USNRC APPLICATION
Combined Source and 11e.(2) Byproduct Material License

December 2014

PREFACE

AUC is pleased to provide this Revised Environmental Report response package. Included in this package are responses to Clarification issues of the NRC staff's Request for Additional Information (RAI) dated Feb. 10, 2014. The staff presented their clarification requests in the form of PM to PM and Public Meetings held during August, September and October of 2014. Any response which quotes specific application content revisions is highlighted in quotations. Red text represents the original text revisions or new additional language proposed in the original RAI response package to the license application. All blue text and blue strikeouts present the revisions to the original RAI responses based on the NRC staff clarification requests. All responses which detail revisions or additional language to the application will clearly list the appropriate application location where those changes will be made.

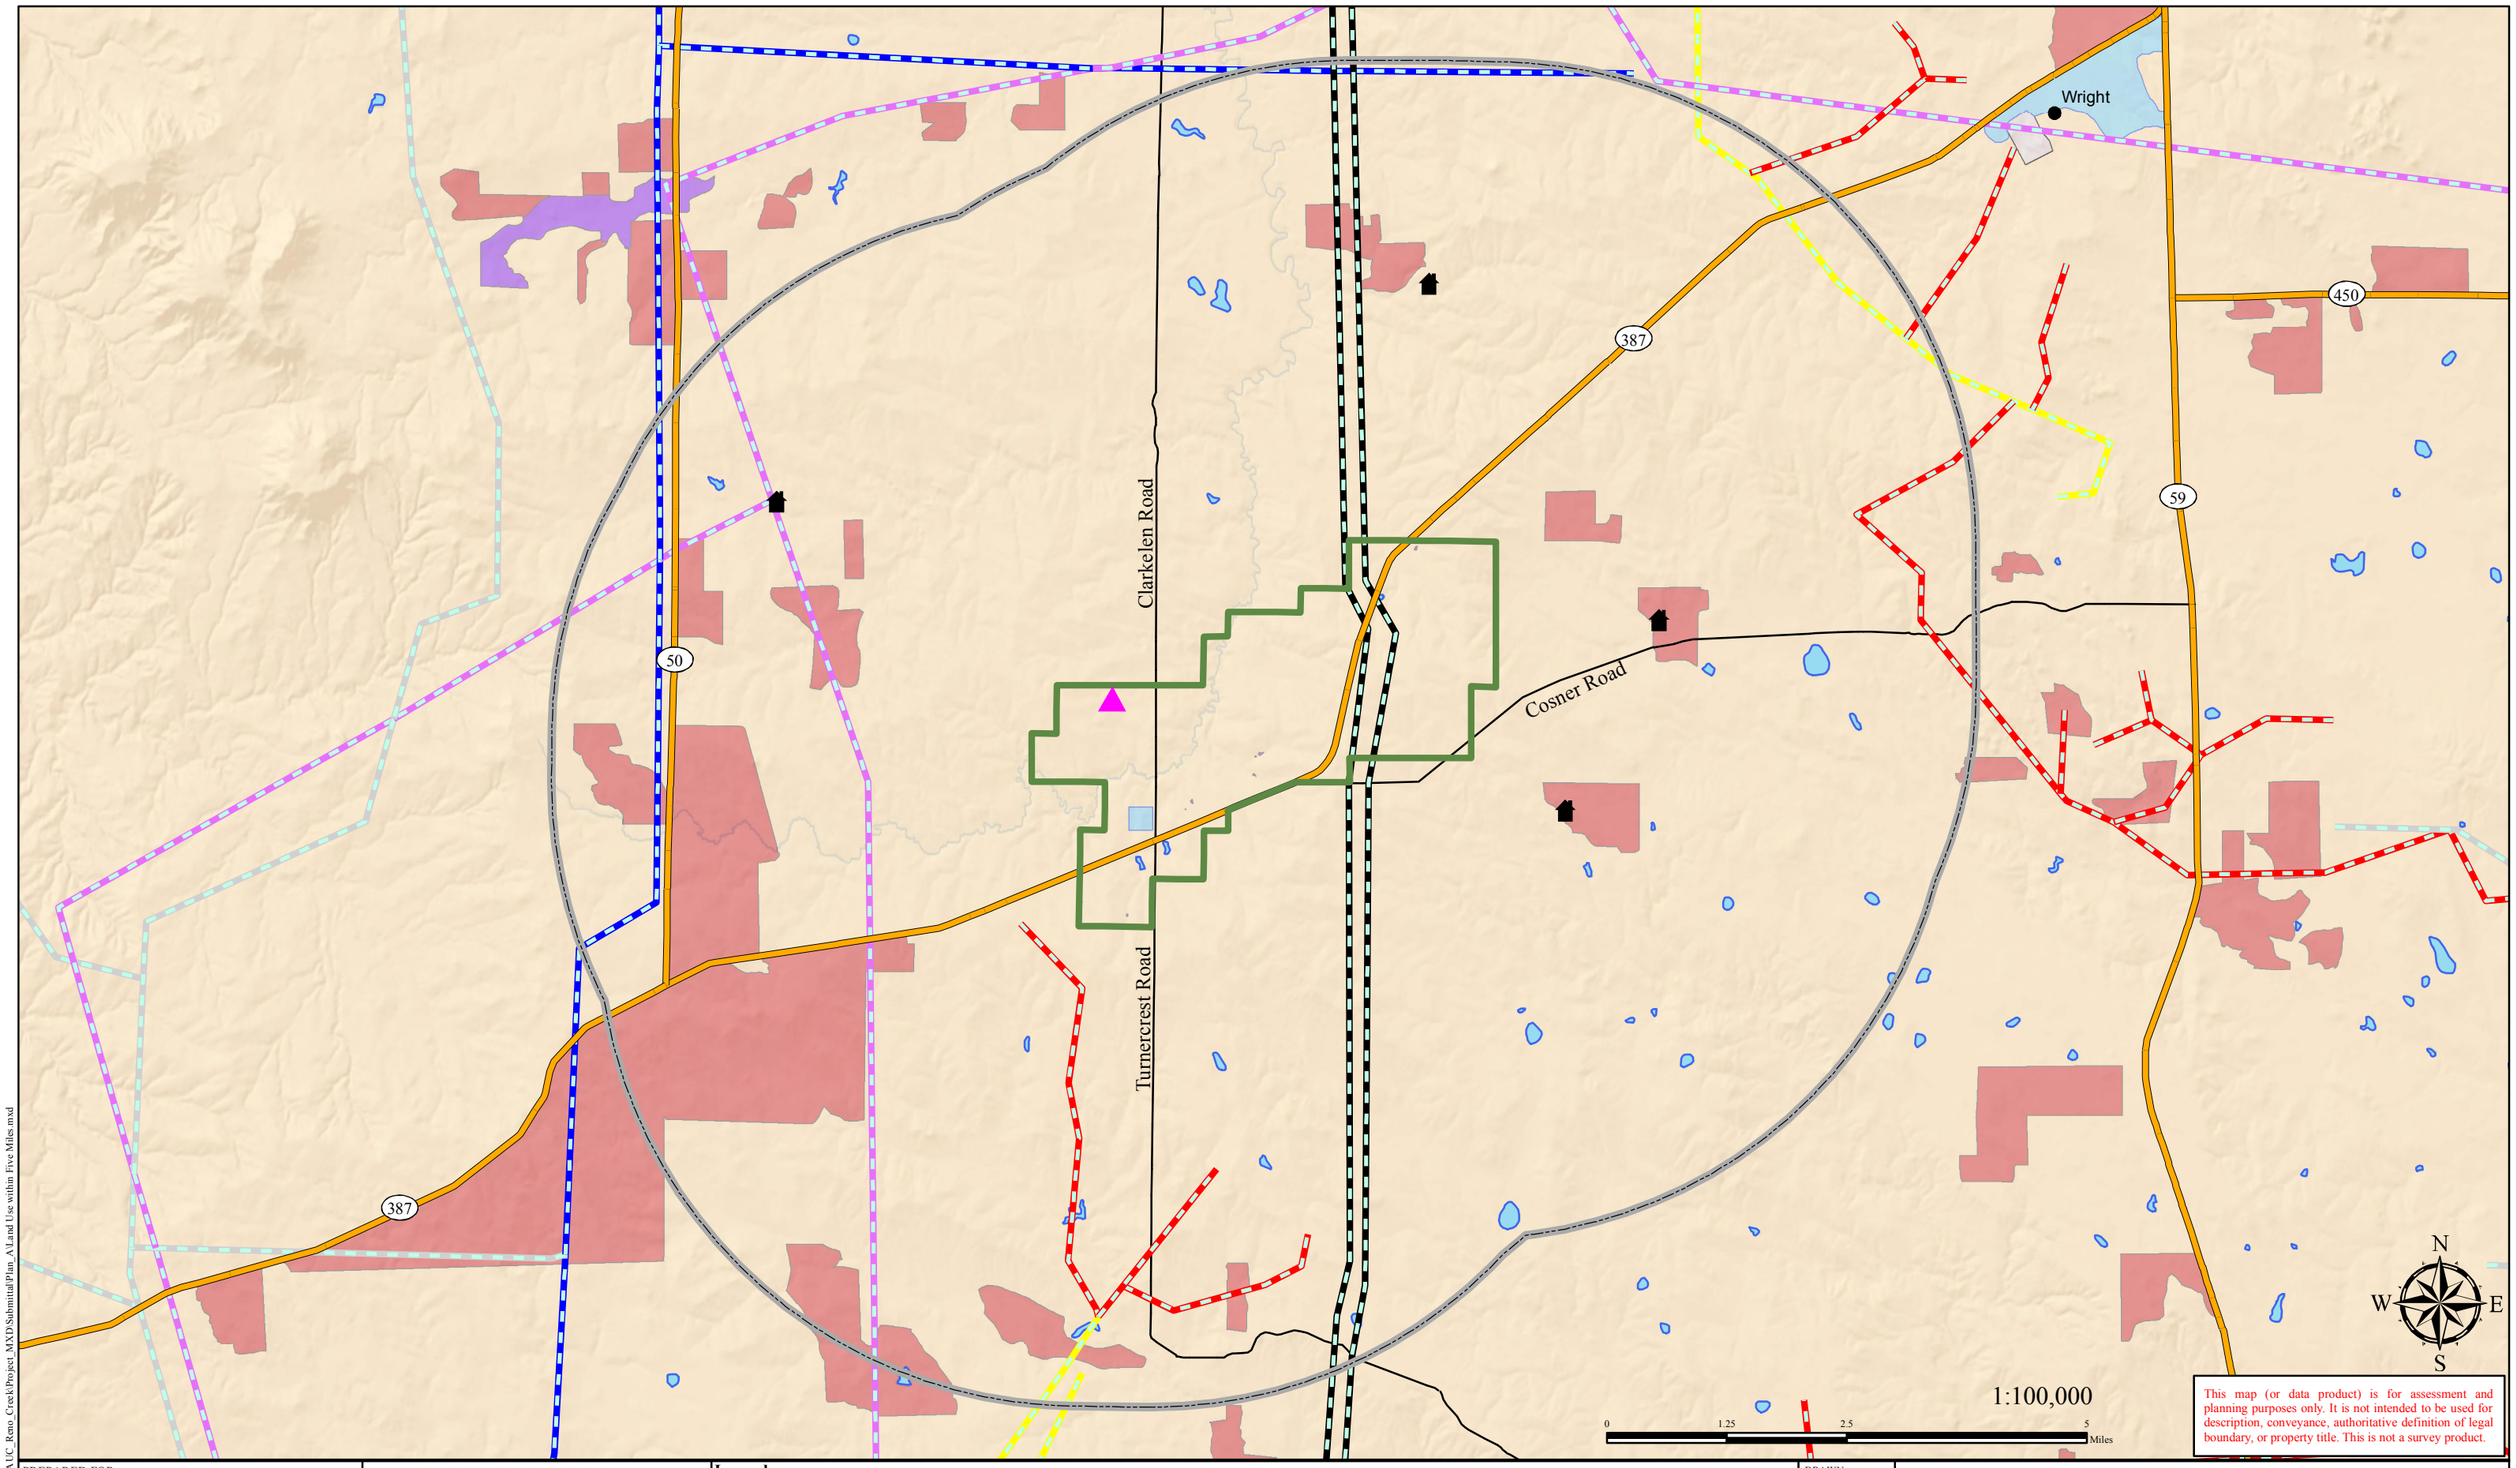
Table 3.1-1 and Figure 3.1-1 of the ER indicate that most land within and surrounding the proposed project is classified as non-agricultural land. This is not consistent with Section 3.1.4 (Agriculture) of the ER, which indicates that land within and surrounding the proposed project is predominantly rangeland used for livestock grazing – an agricultural activity.

Both Table 3.1-1 and Figure 3.1-1 have been updated to reflect this change and are shown below.

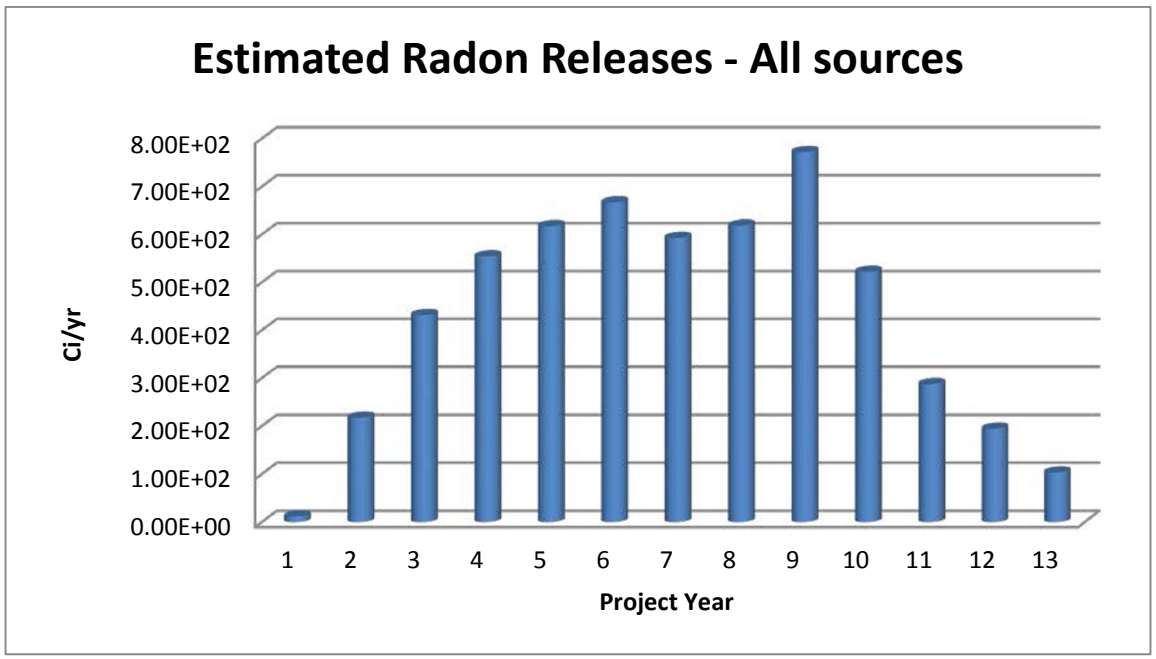
b) *Verify that the annual estimated radon release values in the graph provided in the response to RAI ER POH-3 are correct. Additionally, verify the values with regard to the proposed project schedule, Figure TR 1-3.*

occur until yr 6 and then continues for the first quarter of year 7. Taking into account the staging and size of each production unit, the profile of Rn releases for years 1 – 13 are as shown in the graph below. The maximum Rn release of 772 Ci occurs in year 9. The graph below will be substituted for the original Table 7 to help clarify the radon release profile.

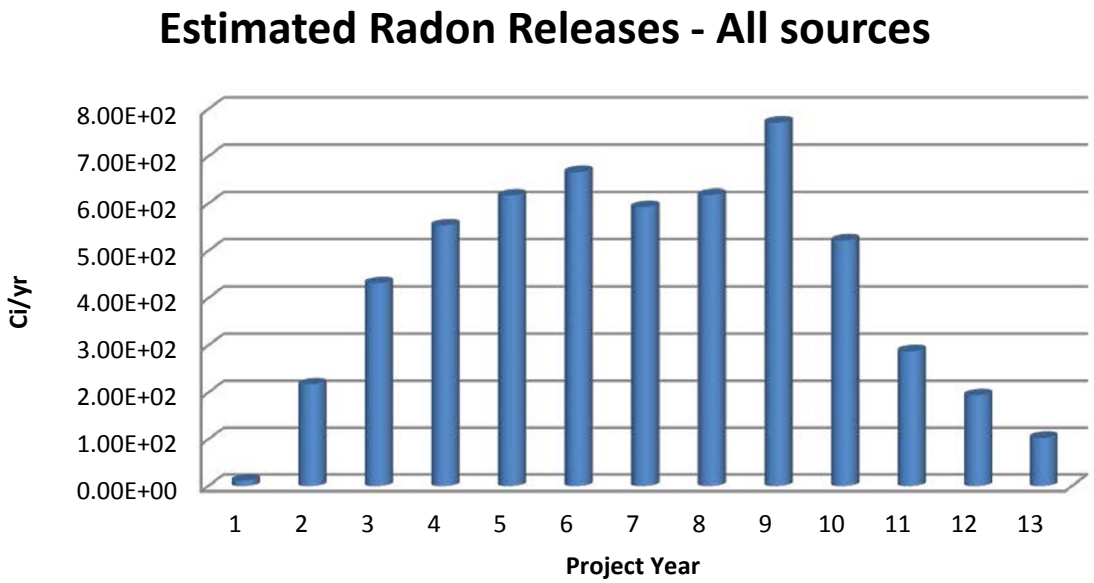
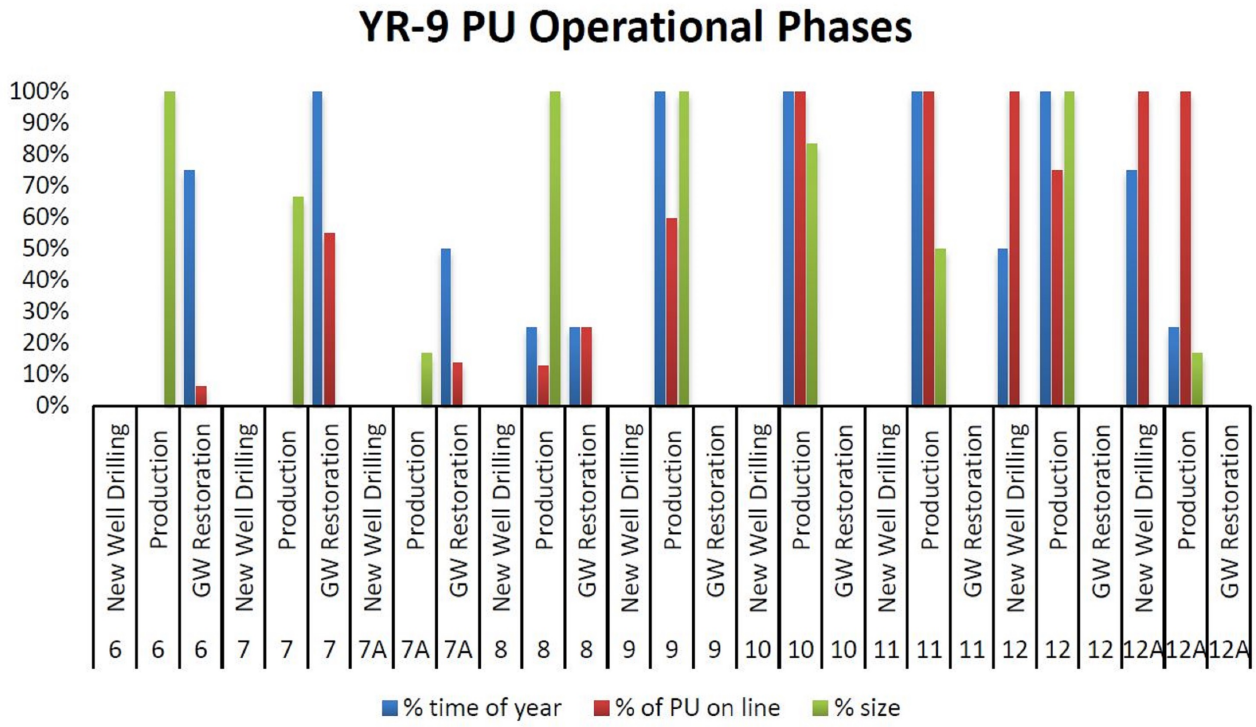
The discussion given in response to RAI ER POH-3 lists the highest release of Rn in any one year (YR-9) is 772 Ci. The MILDOS model has calculated this value based on various PUs in various stages of operations and installation during YR-9.

Even though PUs 7A through 12A are shown as operating in YR-9 only PUs 10 and 11 are operating at 100 percent capacity throughout the entire year. PU9 operates for the entire year, but only at 60 percent of its design capacity. PUs 7A, 8 and 12, which are online during YR-9, are operating for only a portion of the year and less than full operating capacity. PU12A operates at 100 percent of capacity, but only for one quarter of the year. Rn releases from the groundwater restoration phases of PUs 6, 7, 7A and 8 are also included in the release calculation. Therefore when calculating the Rn releases for a particular year the time on line as well as the percent of the PU in operation must be considered. Additionally the number of wellfields within a given production unit must be considered. This combination of these three factors, number of wellfields, time on line and the percent of the PU on line will result in lower Rn releases than if only the time on line is considered ith each PU on at full capacity. The figure shown below breaks out these three factors for the PU in operation for YR-9.

DRYER FLOW DIAGRAM
AUC
RENO CREEK

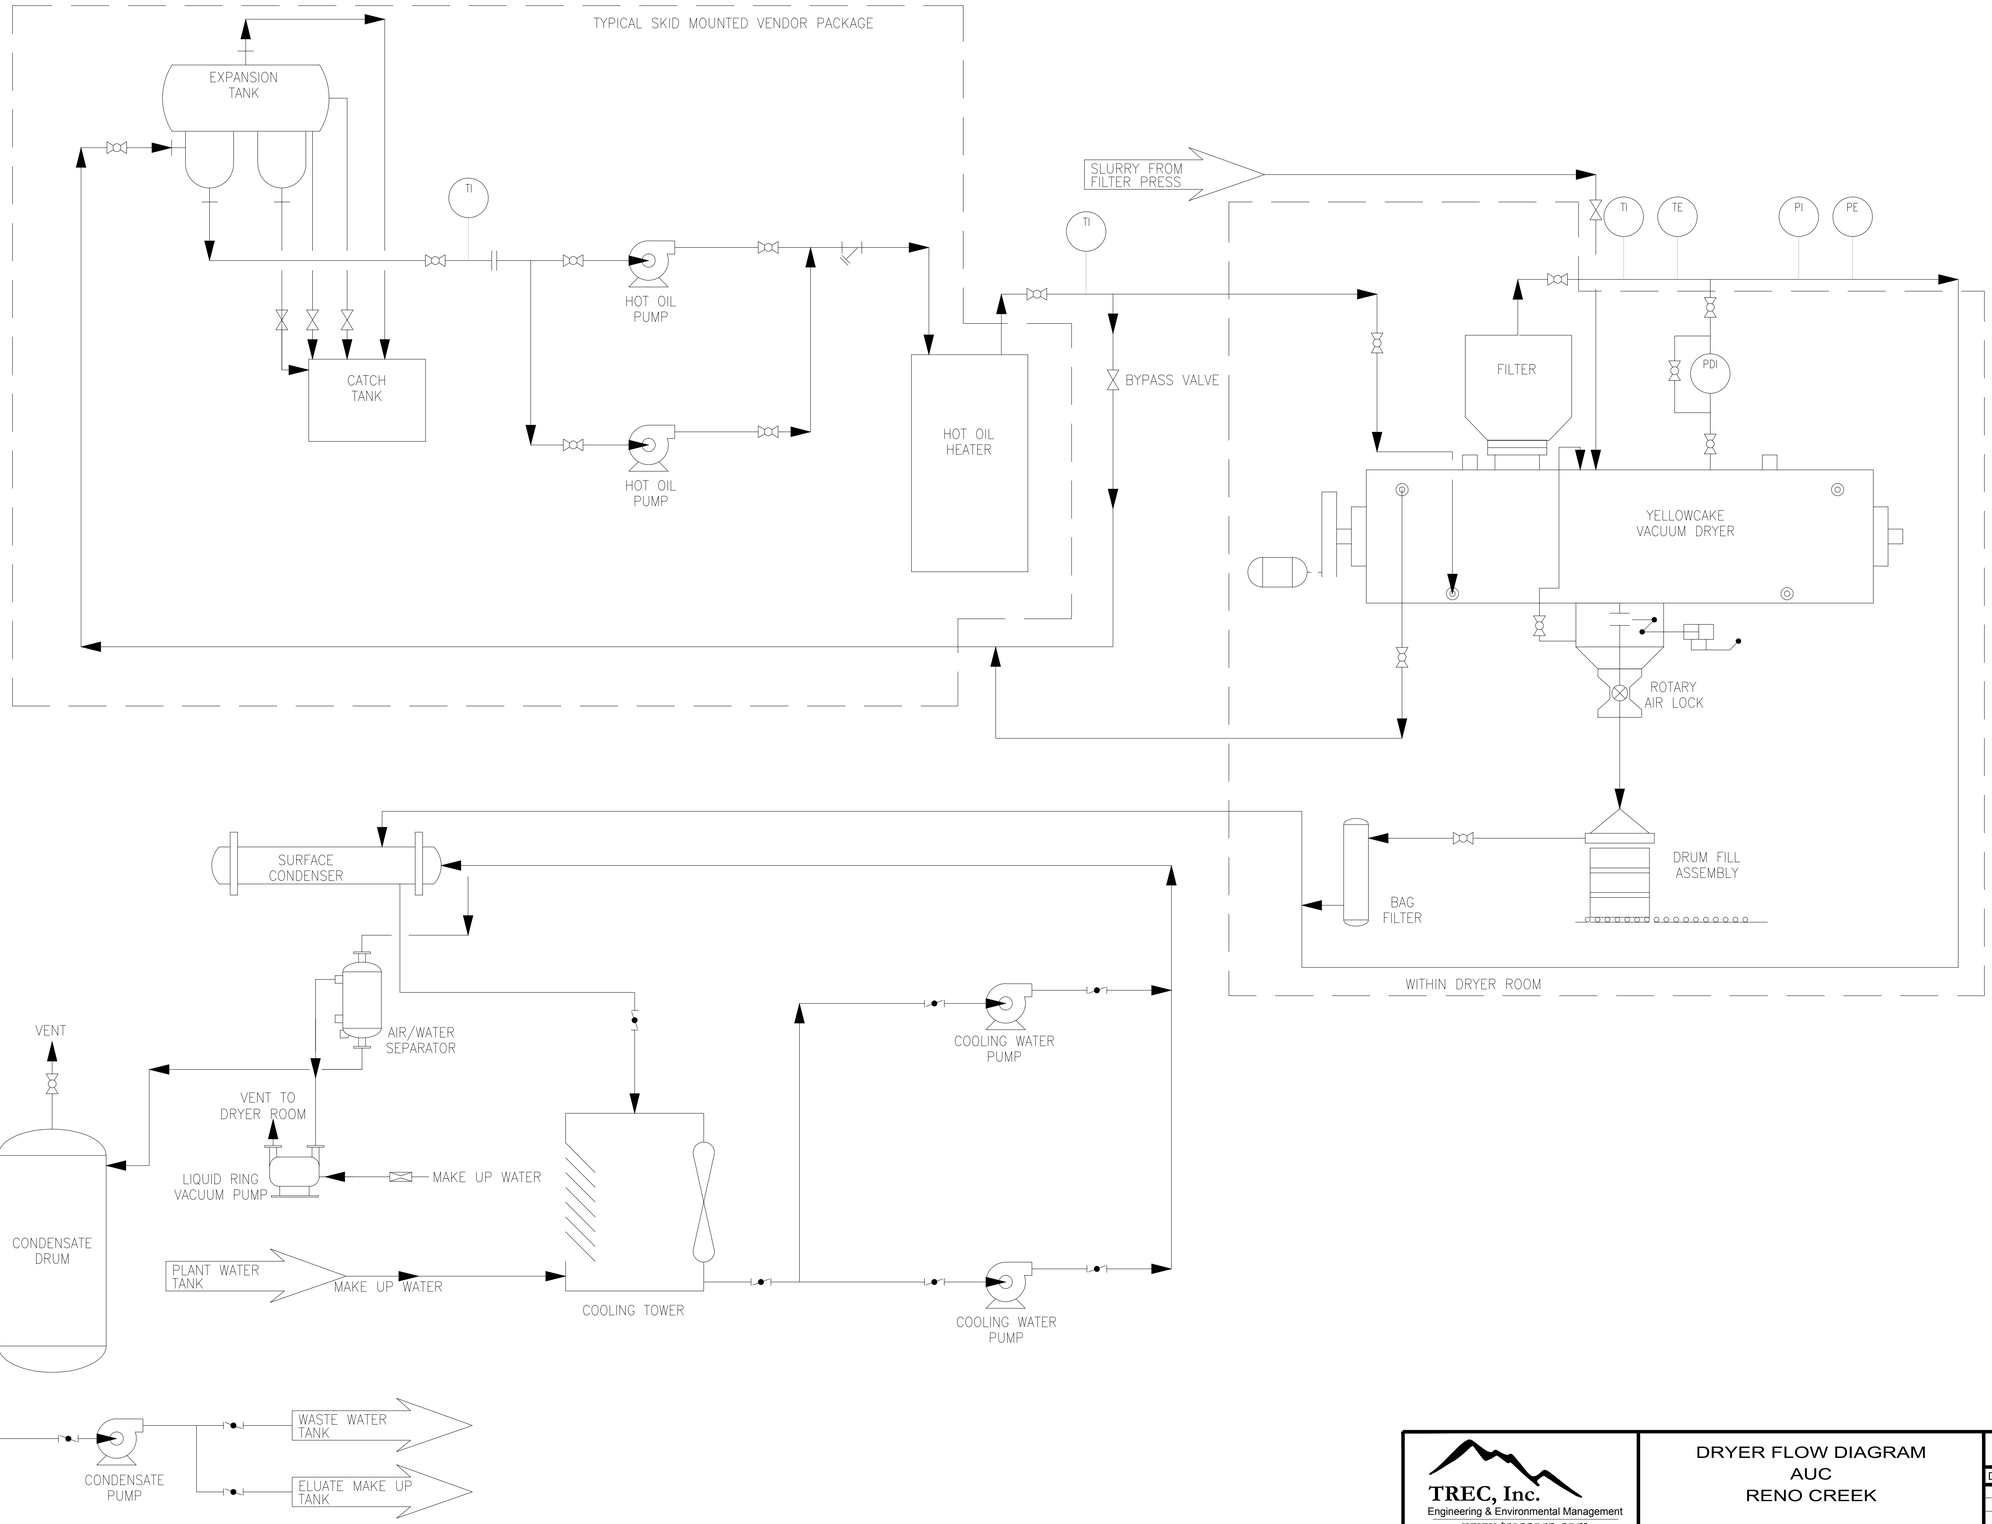
Section 3.2.1.4 (Yellowcake Drying and Packaging System) of the TR references Figure 3-10; however, this figure could not be located in the TR.

Provide missing Figure 3-10. Additionally, provide a complete description of the proposed yellowcake dryer so that the potential impacts from yellowcake drying, including worker safety and radiological air emissions, can be evaluated.

A comprehensive description of the yellowcake drying process is provided in TR Section 3.2.1.4. To further clarify the yellowcake drying process, TR Figure 3-10 depicting the yellowcake drying and packaging system has been added to the application and is shown below:
